Informal document GRSP-60-19
(60th GRSP, 13-16 December 2016,
agenda item 14)

Explanation to Doc -/GRSP/2016/18

GRSP item Reg.44-CRS, Geneva December 2016

Detail fixture that is used by car manufacturers, the original is in R16, Annex 17, Appendix 1

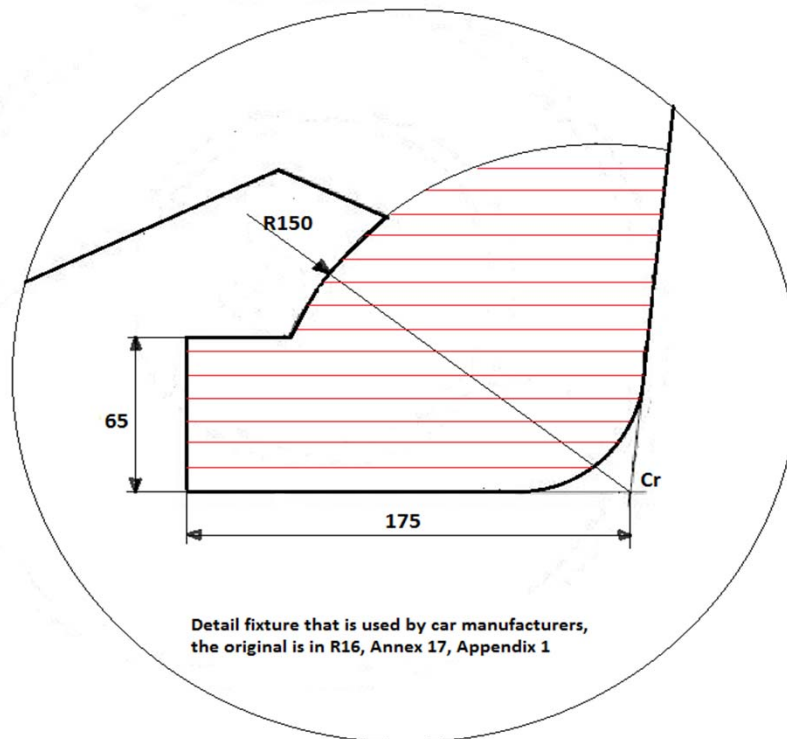
Car manufacturers utilize R16, Annex 17, Appendix I, so can use the red faded zone.

However R44 (and R129) are written such that Child restraint manufacturers have to respect only the 150 mm.

So, low boosters, only fulfilling R=150 mm cause incompatibility, this must be improved!
